Project: **TOUCHSTONE VILLAGE CENTER**  
 for: **CROSLAND GROUP**  
 Sheet Title: **REZONING PLAN**

SUBJECT: Administrative Approval for Petition #90-13  
 Tax Parcel #223-025-02

SUBJECT: Administrative Approval for Petition No. 90-13 by Touchstone Assoc. Ltd. Partnership Tax  
Parcel # 223-025-02

SUBJECT: Administrative Approval for Petition No. 90-13 by Touchstone Associates Ltd. Partnership  
Tax Parcel # 223-025-02

Print Number: **2094-X4**  
 Sheet No.: **SF - 1**

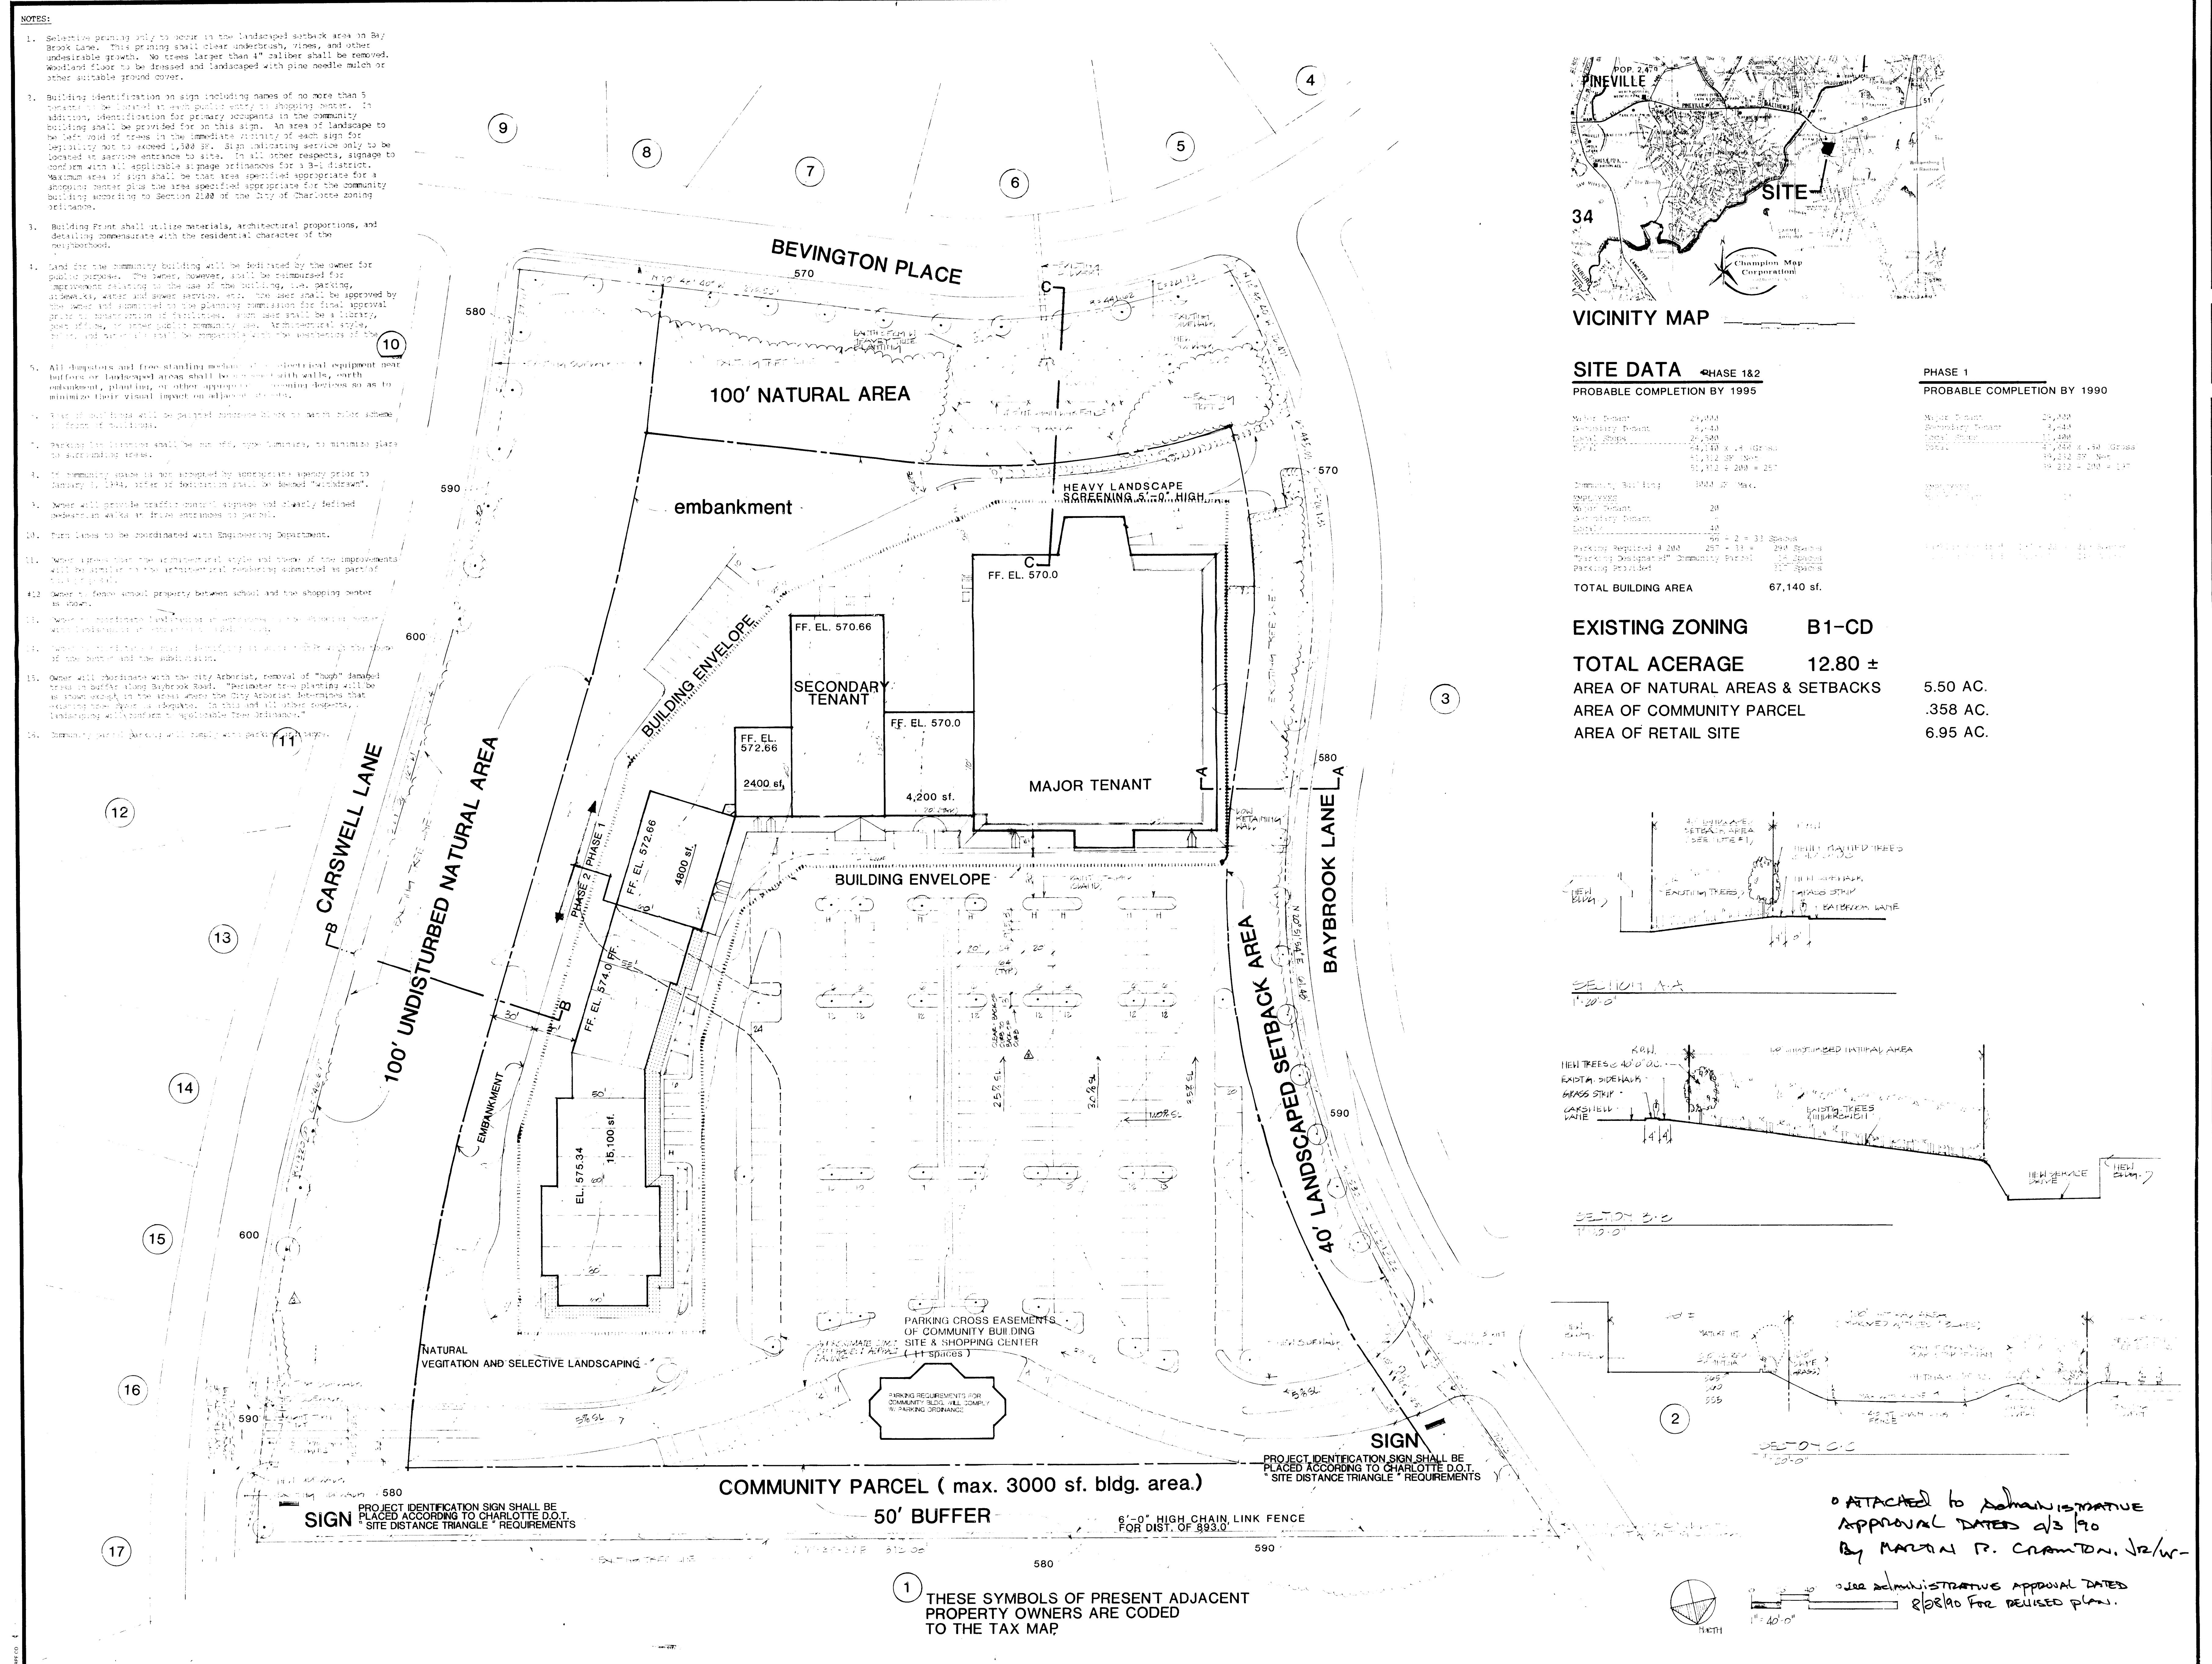
Attached is a revised plan for the above mentioned zoning petition. The petition has been revised to eliminate eight proposed trees along Carswell Lane. These trees are not needed due to the large number of existing trees along portions of Carswell Lane. If these trees were planted existing trees would have to be removed. Since this change is minor in nature I am administratively approving this plan. Please use this plan when evaluating requests for building permits.

ATTACHED TO ADMINISTRATIVE APPROVAL  
DATED: 6/11/96  
BY: MARTIN R. CRANTON, JR.

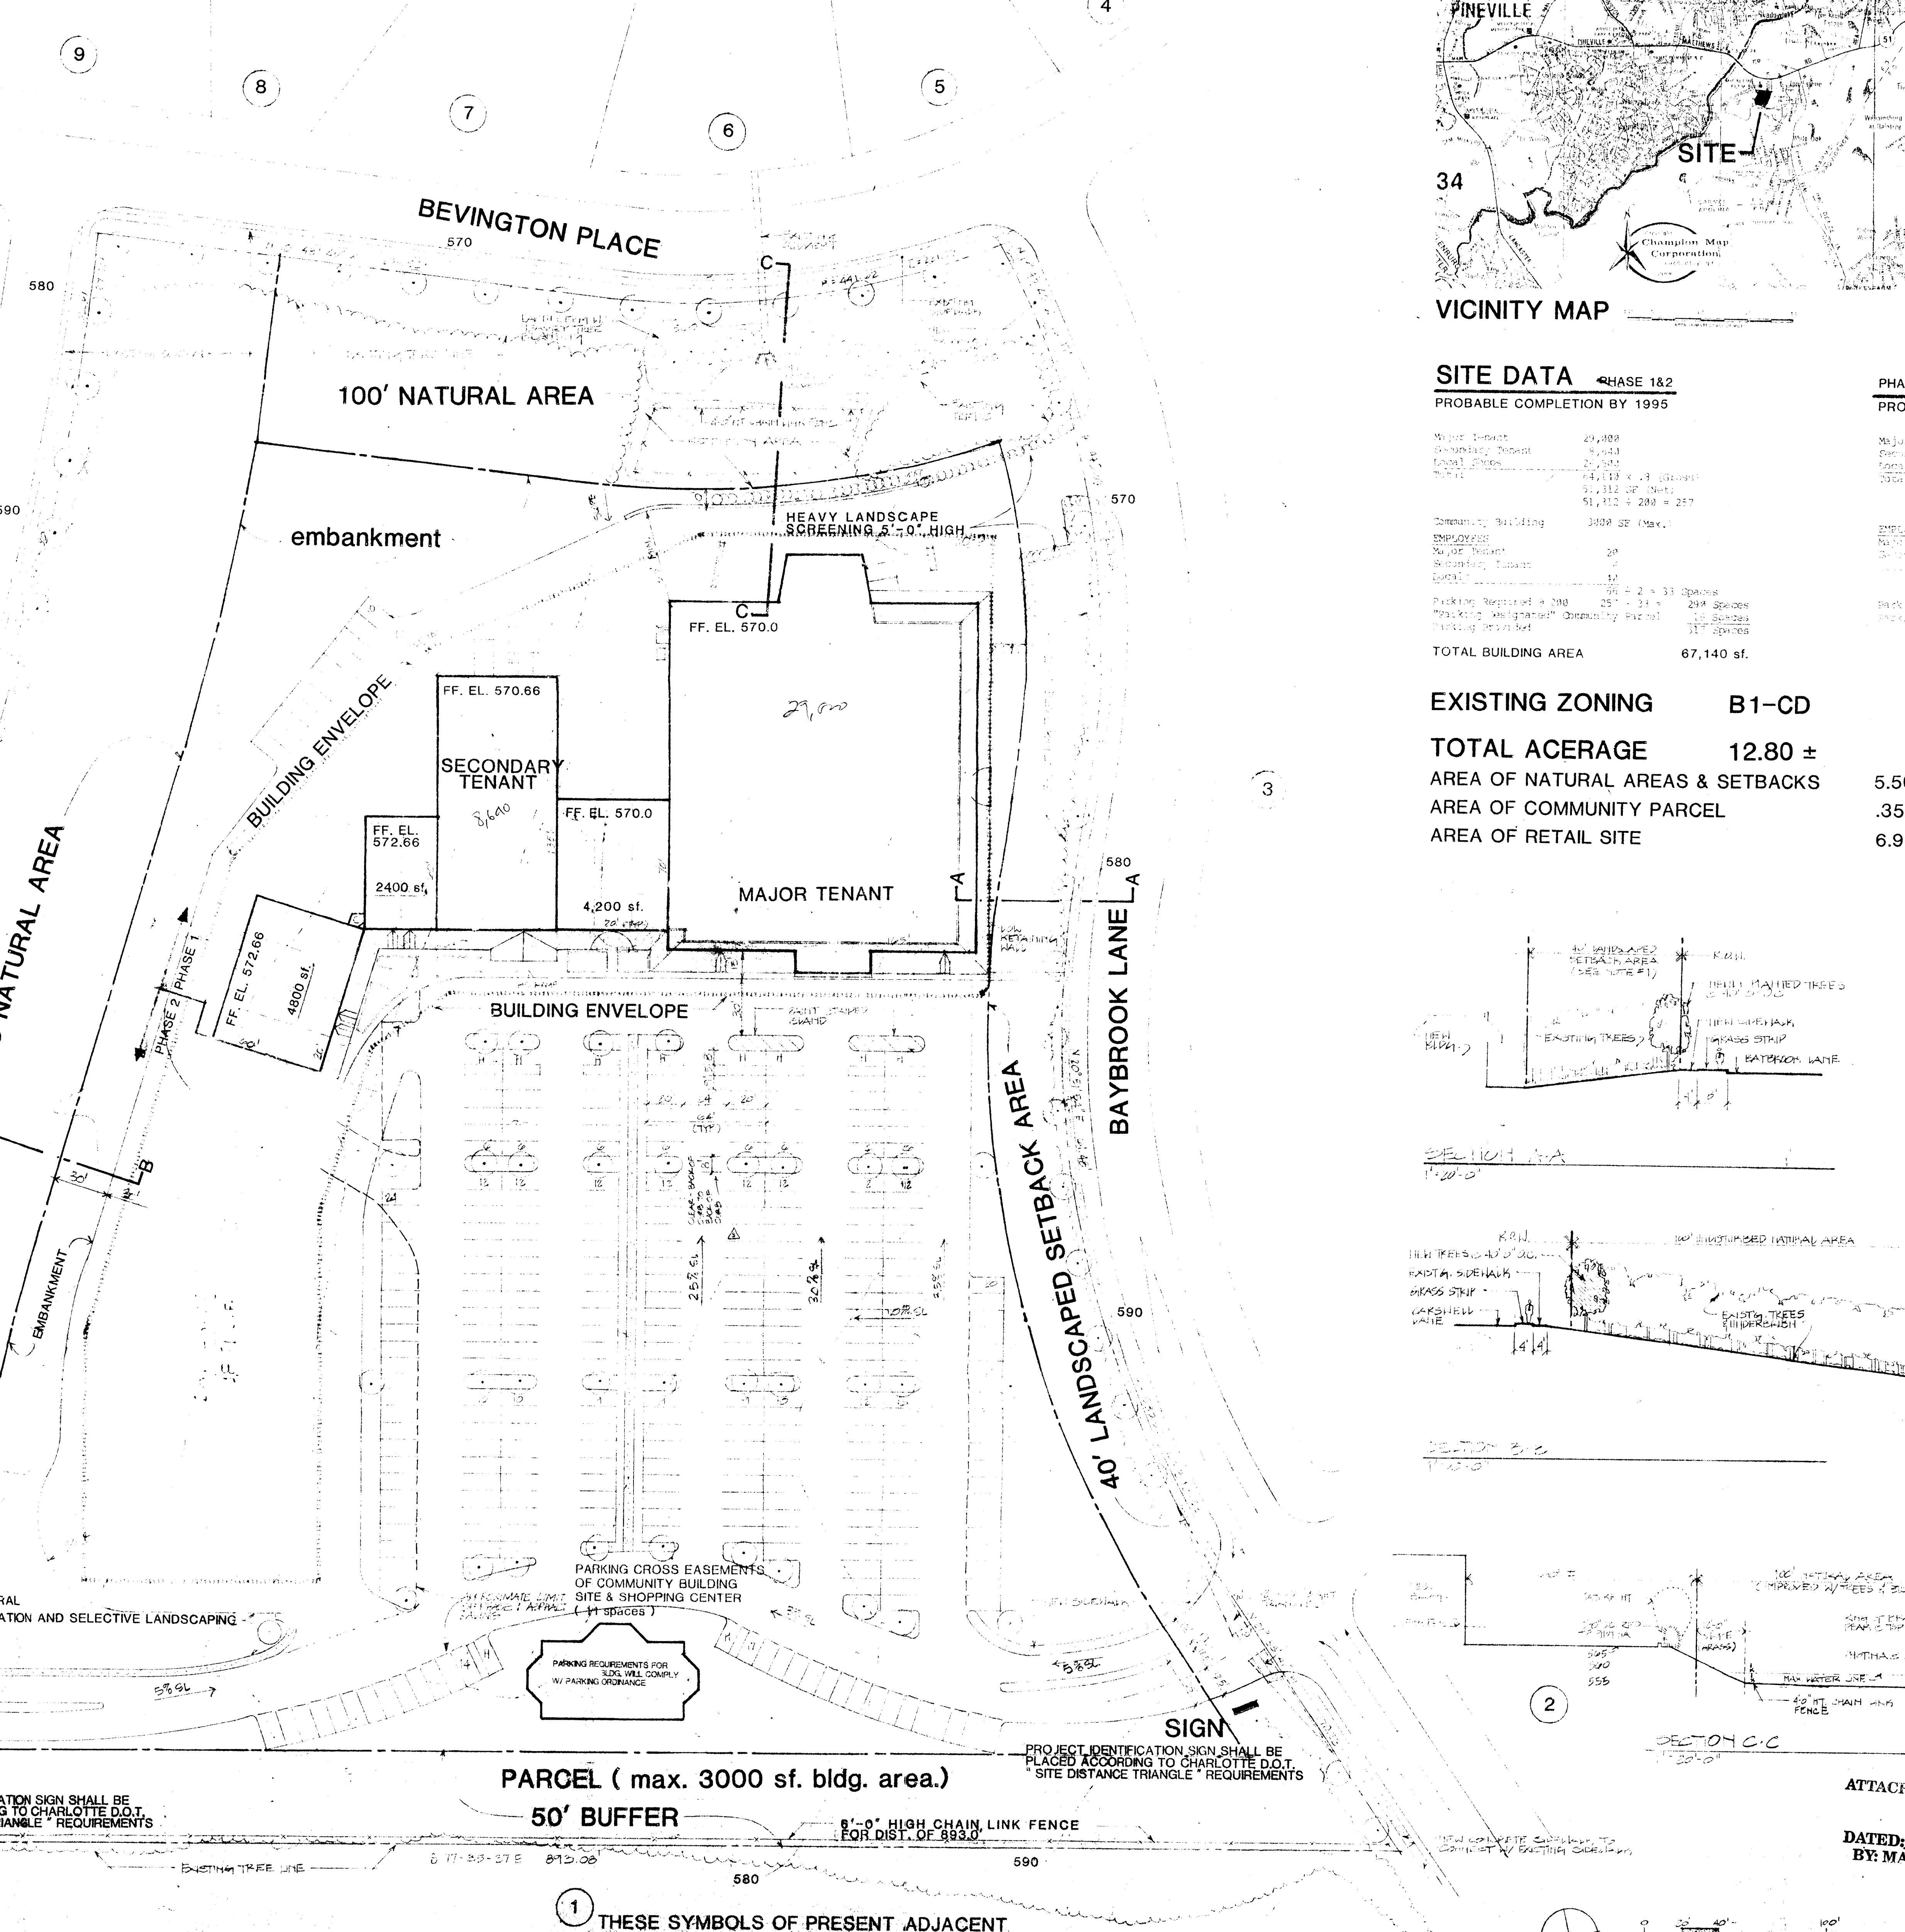
Attached is a revised plan for the above mentioned rezoning petition. The plan has been revised to eliminate the commitment to a 3,000sqft. Community Park. The originally approved plan had committed to making this parcel available upon request by a community organization. The plan had also stated that any such request would need to occur prior to January 3rd 1994 otherwise the offer of dedication would be withdrawn. Since this date has passed and no request has been made by any community organization the owner has requested that we administratively approve a revised plan that eliminates the commitment to the community park and allows the community parcel building to be used for any use allowed by the approved conditional plan and the B-1 zoning classification. The square footage of any building built on this parcel will be limited to 3,000sqft. and subject to all other conditions of the approved conditional plan.

Since this change is minor and the total square footage for the center has not been exceeded and the commitment to dedicate the community parcel has elapsed we are administratively approving this revised plan. Please use this revised plan when evaluating request for building permits and certificates of occupancy.
